# Technical Bulletin

Bulletin Number: 253 Revision Number: R-03

**SUBJECT:** DRIVE ARM / LINKAGE ARM

**MODELS AFFECTED:** DNCB Dual Adaptables, T-Models, and E-Models  
DN Adaptables and Dual Adaptable Models

Figure 1

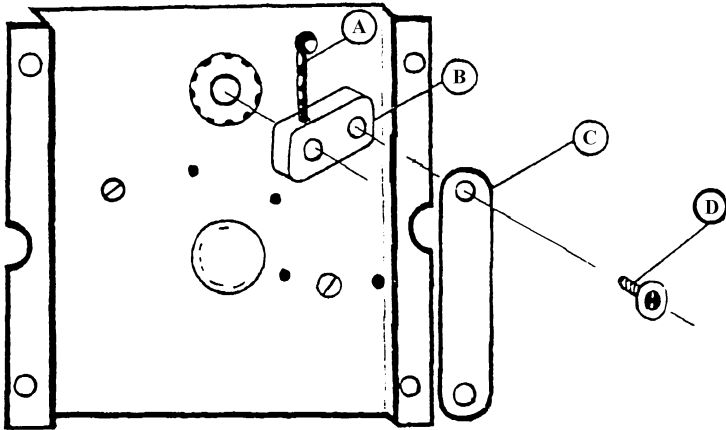
**PARTS:** A) Plastic Drive Arm and Linkage Arm beginning 0001-6271CT (8-21-95) on all models except E-Model venders. Including 1675 to 1773-6241BT. See figure 1, page 2.

Drive Arm	801,806,160.21	Current as of 1/1/97
Linkage Arm	801,806,170.01	Current as of 1/1/97

Figure 2

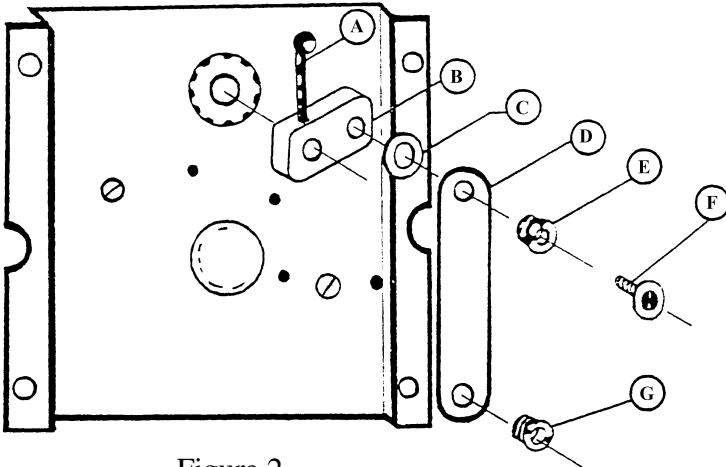
B) Zinc Drive Arm and Linkage Arm beginning 0001-6378DU (11-4-96) on E-Model Venders. See figure 2, page 2.

Drive Arm	801,200,950.91	Current as of 1/1/97
Linkage Arm	801,201,590.21	Current as of 1/1/97

E-Model Venders 0001-6368DU (10-7-96) to 0001-6378DU (11-4-96).

Drive Arm	801,806,160.01	replace with 801,806,160.21
Linkage Arm	801,201,590.01	replace with 801,806,590.21

Figure 3

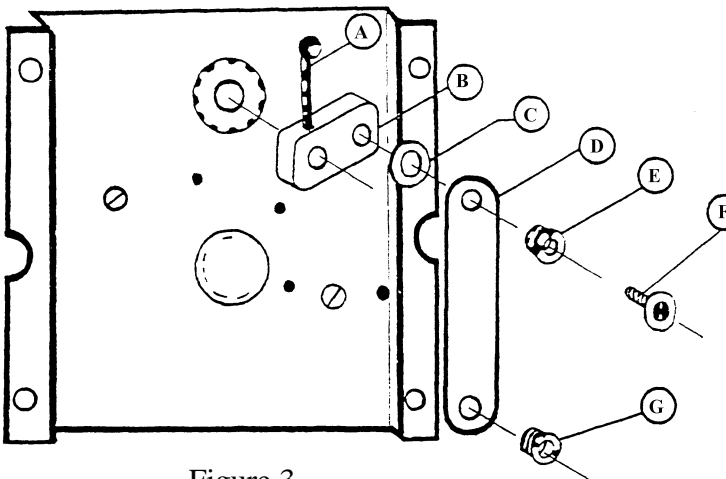
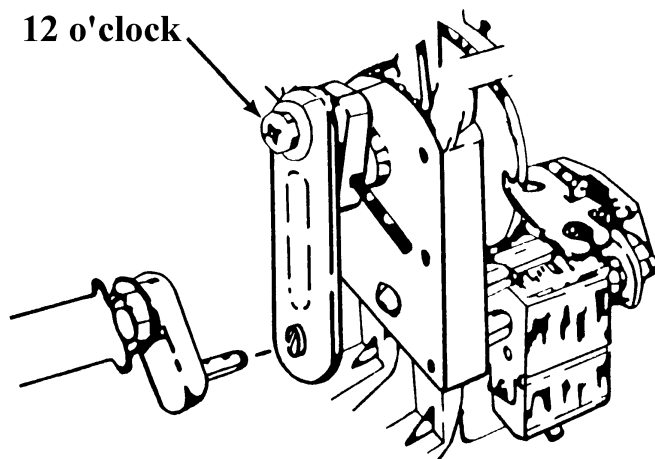
C) Zinc Drive Arm and Linkage Arm prior to 0001-6271CT. See figure 3, page 2.

Drive Arm	801,200,950.91	replace with 801,806,160.21
Linkage Arm	801,201,030.11	replace with 801,806,170.01

Drive Arm / Linkage Arm  
Figure 4

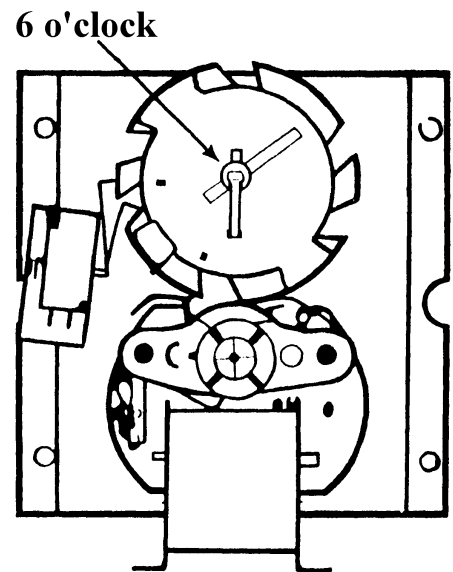
1.
  - A) In Series 90 venders: The lock tab of the vending cam should be at the 6 o'clock position. See figure 5.
  - B) In Pre-Series 90 venders: The pin that secures the cams to the motor will be horizontal and the adjustable cams locking screw is in the 6 o'clock position. See figure 6.
2.
  - A) In Series 90 venders: Place the Drive Arm in position so it is in a vertical position with the screw that secures the Linkage Arm to the Drive Arm in the 12 o'clock position. See figure 4.
  - B) In Pre-Series 90 venders: Place the Drive Arm in position so the Drive Arm is in a vertical position with the screw that secures the Linkage Arm to the Drive Arm in the 12 o'clock position. See figure 4.
